Changes to v14 (2015-06-03)
 - Adapted drill for alignment pin of INTERFACE_TO_UC
 - added optional headers for Serial Wire Interface

Driver Board

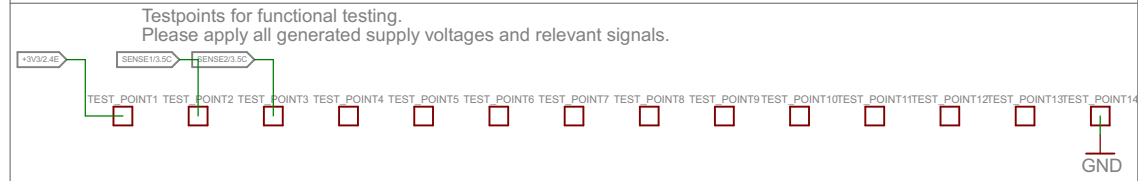
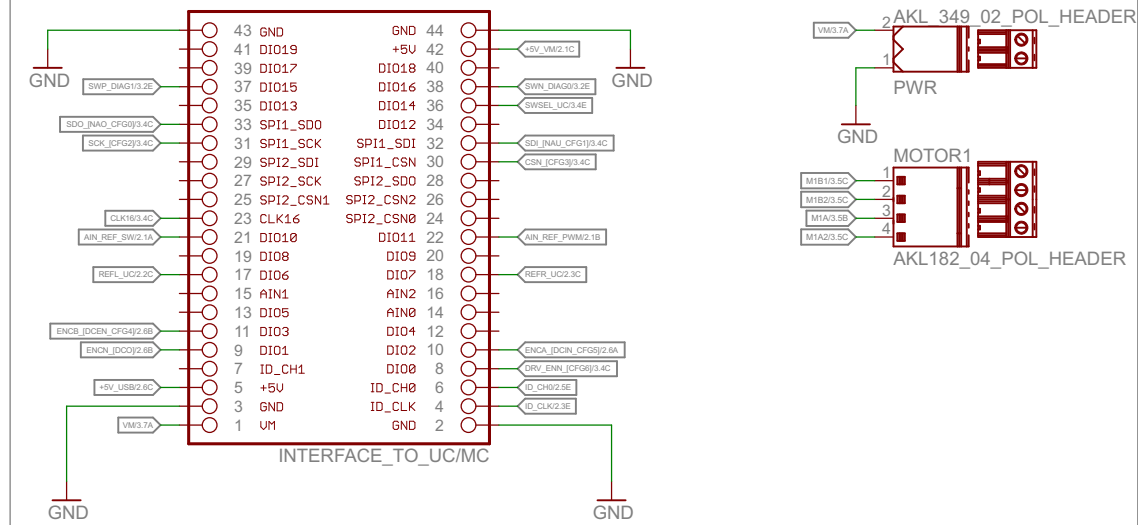
Please keep positions of all interconnectors if not absolutely impossible.
